Morris Goding
Access Consulting

RE: Sirius Redevelopment - Response to Department of Planning, Industry and Environment Accessibility Statement Final

SIRIUS SITE
2-60 CUMBERLAND ST, THE ROCKS
B.V.N. PROJECT NUMBER

DDA APARTMENTS_TYPE 3H
AND 3F

1 DDA TYPE 3F - 14.15.02 - PRE

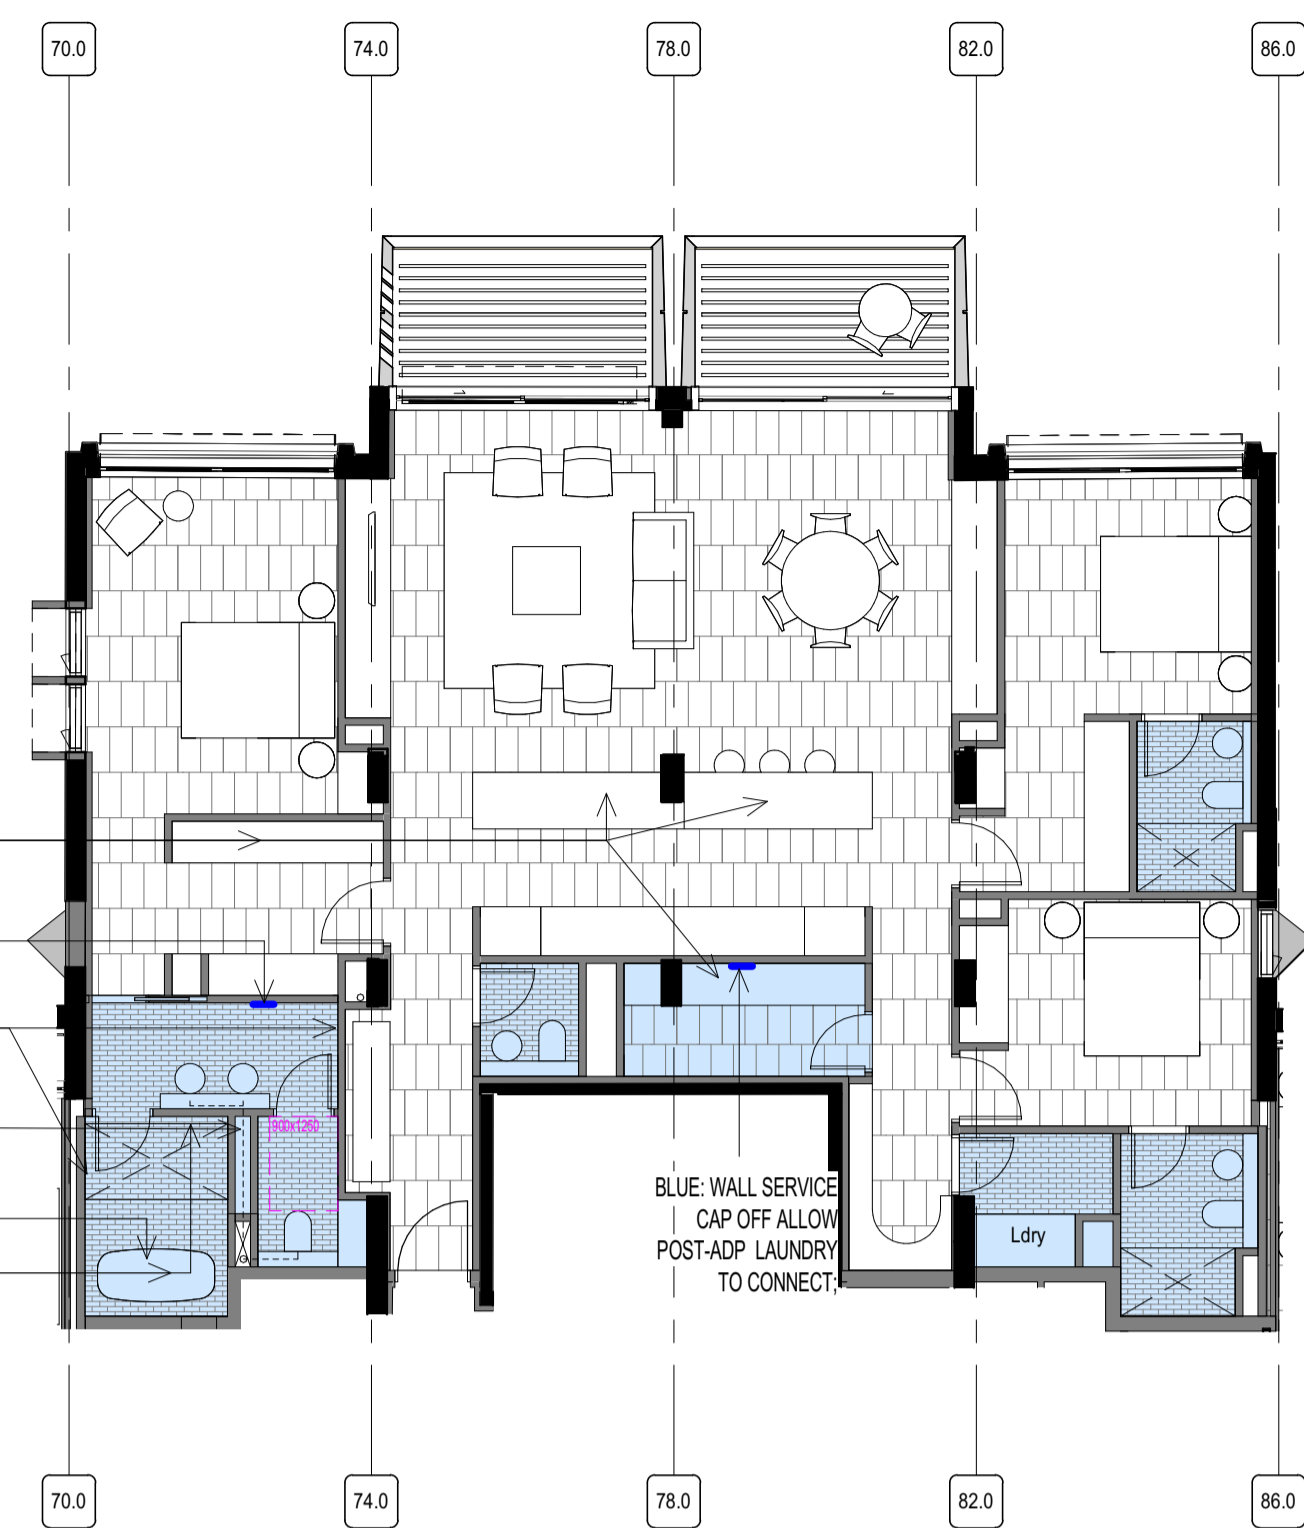
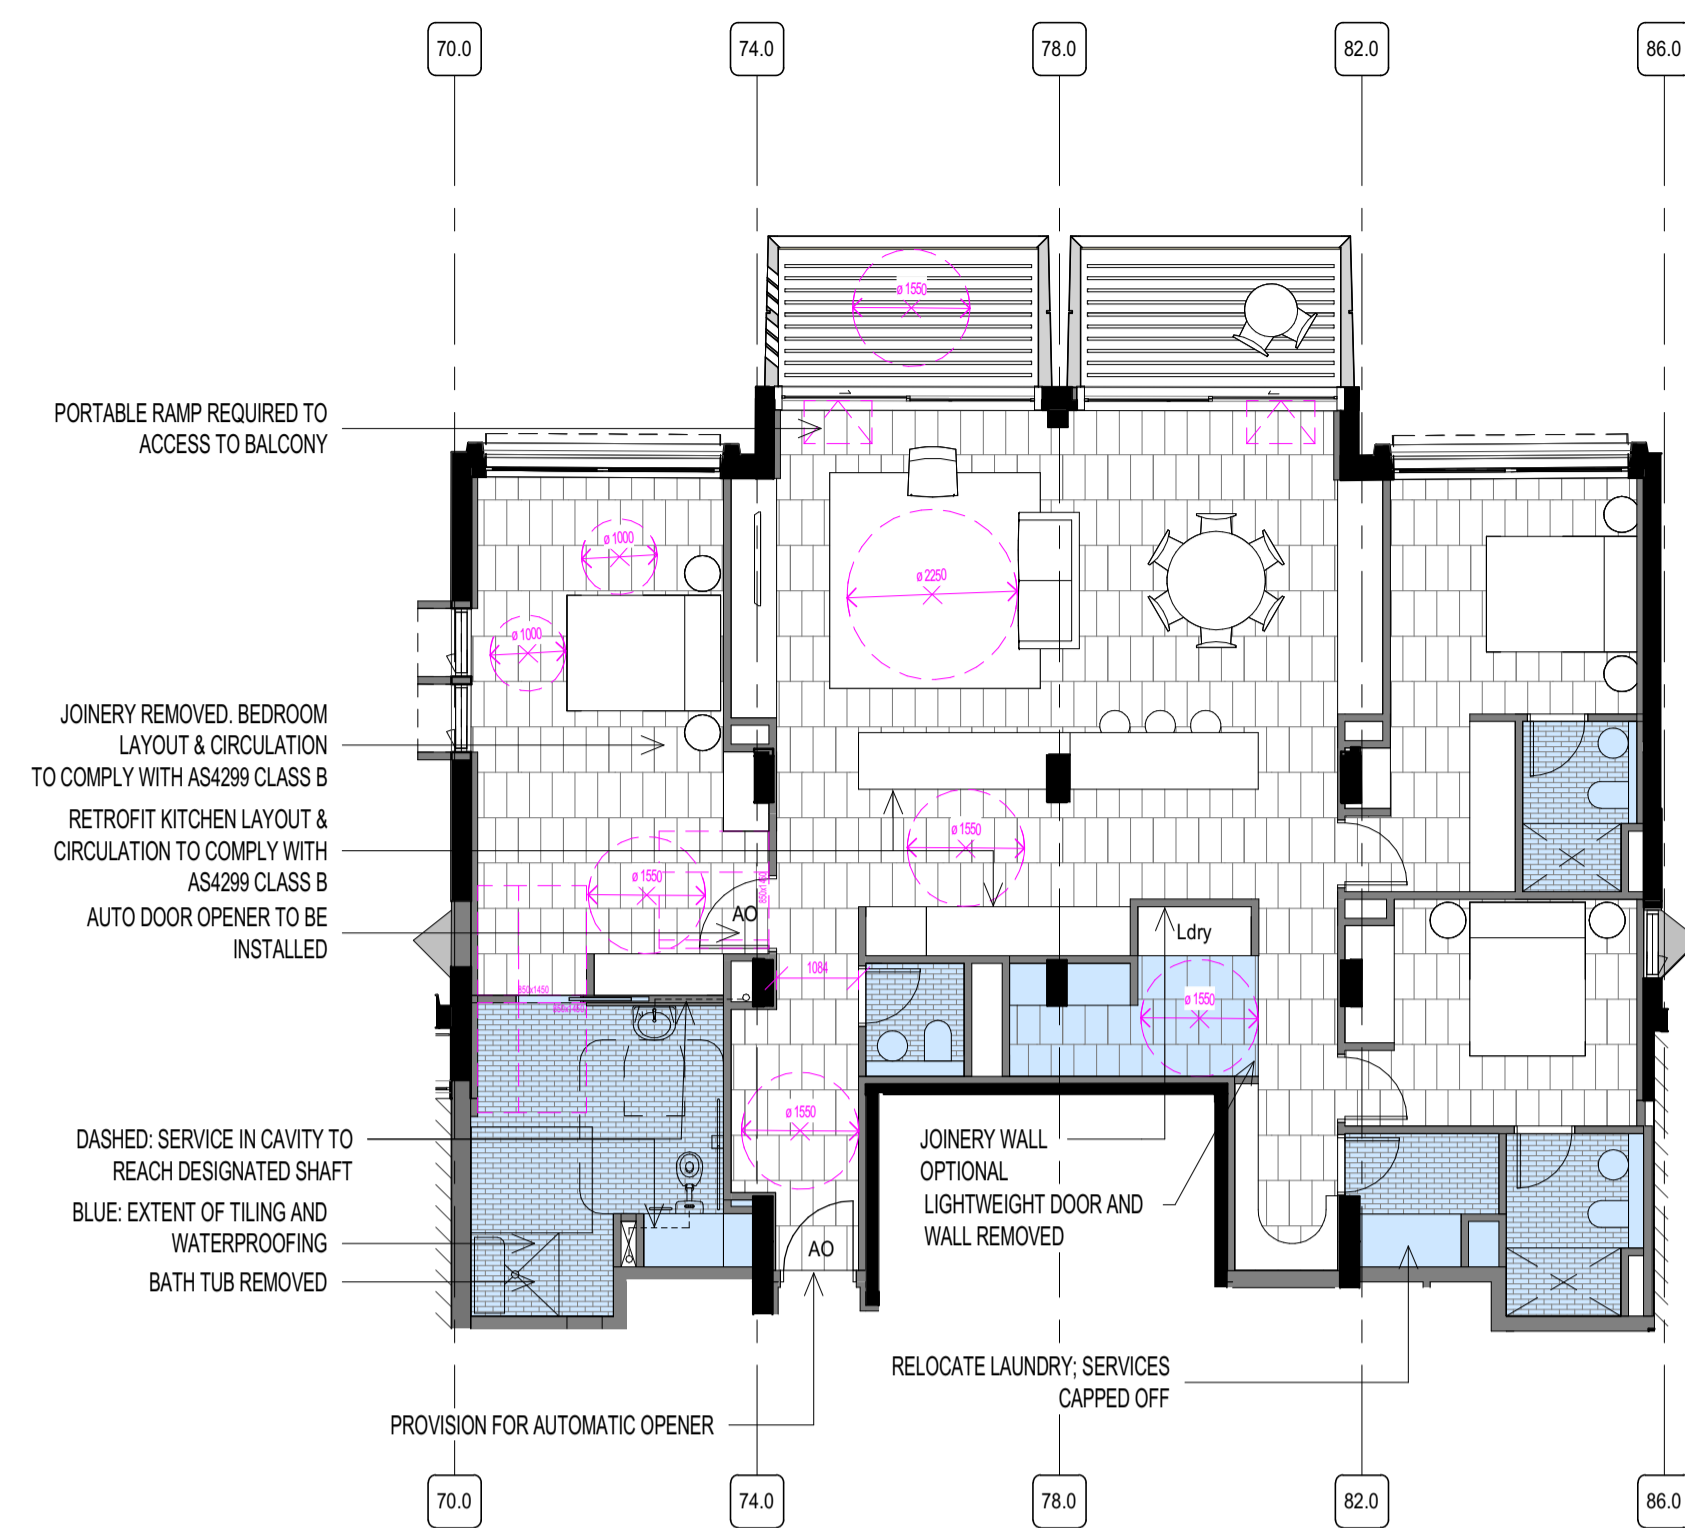
- Within the bedroom of adaptable unit type 3F it is proposed to the remove some of the wardrobe joinery to provide the circulation space required around the queen bed in the adaptable bedroom. While there is a reduction in wardrobe space in the post adaption scheme, there is still ample wardrobe space allocated with significant circulation space as is desirable in AS4299 Clause 4.6. With the greater circulation provided by the removal of the extra wardrobe space, there is some flexibility for the owner to provide additional wardrobe space if desired, while maintaining circulation space around the queen bed. It is MGAC's opinion that the current scheme meets the intent of AS4299 with regards to the bedrooms.

3 DDA TYPE 3H - 18.19.01 - PRE

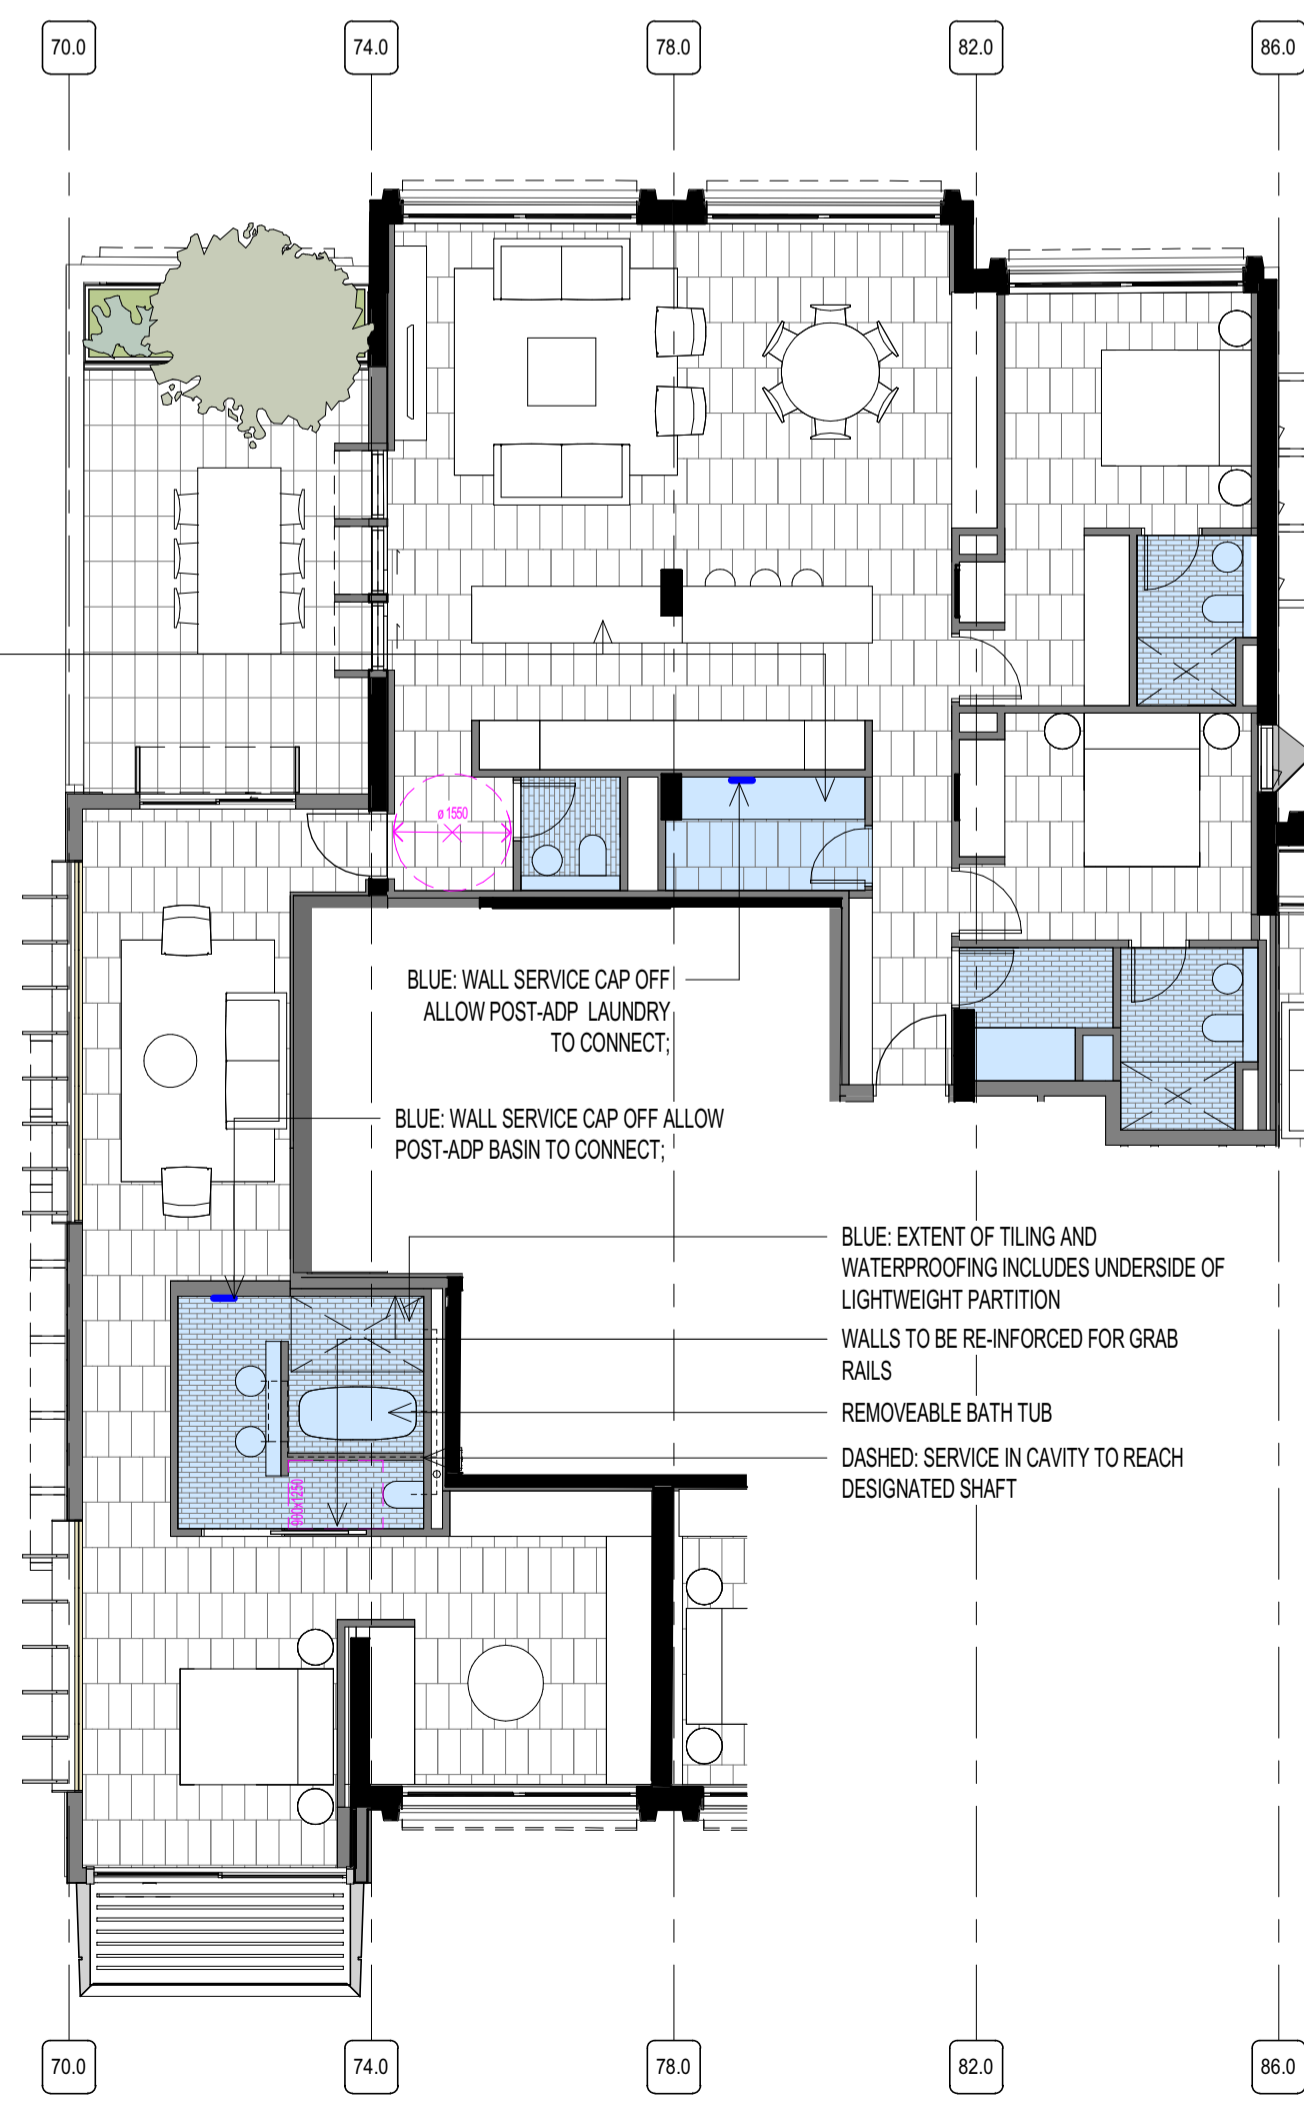
- The accessible bathrooms to adaptable unit types 3F and 3H will show toilet pans and shower recess falls retaining their position between pre and post adaptation and capped off services for the where the washbasin will be relocated at post adaptation are included from the outset. The walls within the bathrooms are annotated lightweight partitions for easy removal at post adaptation. Waterproofing includes the underside of these lightweight partitions. Wall strengthening will be provided from the outset in the toilet pan and shower recess walls to allow for easy future installation of grabrails as per AS4299. As per the provisions of AS4299, a removeable bathtub is permissible.

- The kitchen island benches in adaptable unit types 3F and 3H may be relocated at post adaptation as stipulated in AS4299. The post adaptation drawings show a potential configuration that will comply with AS4299 Clause 4.5. The drawings show continuous flooring underneath the island kitchen bench and the sink waste will be located at the back of the bench such that upon adaptation, the existing joinery can be shifted back to achieve the required circulation spaces. It is MGAC's opinion that the provision of continuous flooring underneath the island bench and suitable location of the sink waste will ensure that adaptation will minimise inconvenience and cost.

- The comments relations to the changes required in the laundry for both adaptable unit types 3F and 3H are noted. Drawings show capped off services in the future location of the laundry provided from the outset and initial joinery can be easily removed as continuous tiling has been provided in this location.
